Proposed Residential Development, Ardshanavooly,
Killarney, Co. Kerry

Stage 1 Road Safety Audit

January 2026

Figure 2.1

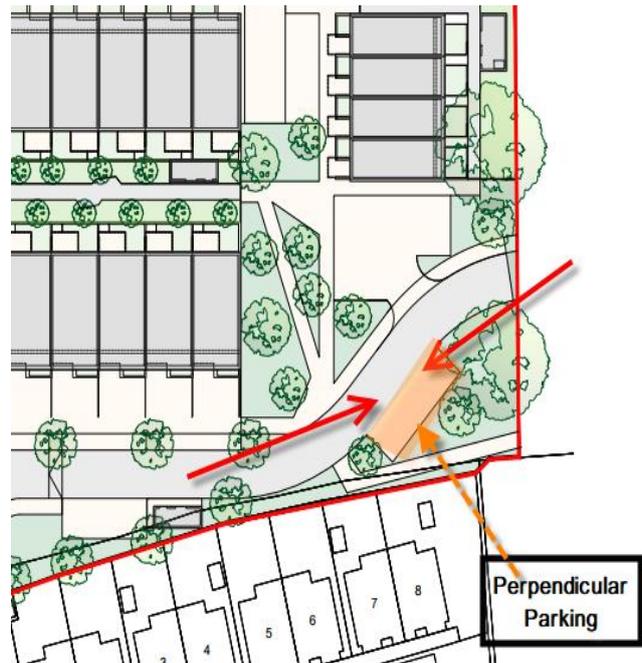
The site layout has made provision to show both a pedestrian and vehicle connection to the future development lands to the east at the south west corner. The design appear to show perpendicular parking along this section of the site on approach/receding from the horizontal road curve. The design guidelines including the forward visibility as set out in the Design Manual for Urban Road & Streets (DMURS) should be provided at this location and internally within the development. Inadequate forward visibility to these parking spaces may lead to collisions between vehicles passing by on estate road and vehicles exiting the parking spots. Refer to Fig 2.1

Recommendation 1

A parking arrangement with an adequate forward visibility envelope is required, in accordance with the relevant standards for the road design speed. The visibility envelope should be kept clear of all obstructions such as wall, hedges, fences, signs etc and vegetation over 600mm in height.

2.1	Y	Y	Layout revised to provide parallel parking in this location to overcome perpendicular parking sightlines issue. Drawing reference 10029 Ardshanavooly - 1003 - 02 - Site Layout Plan
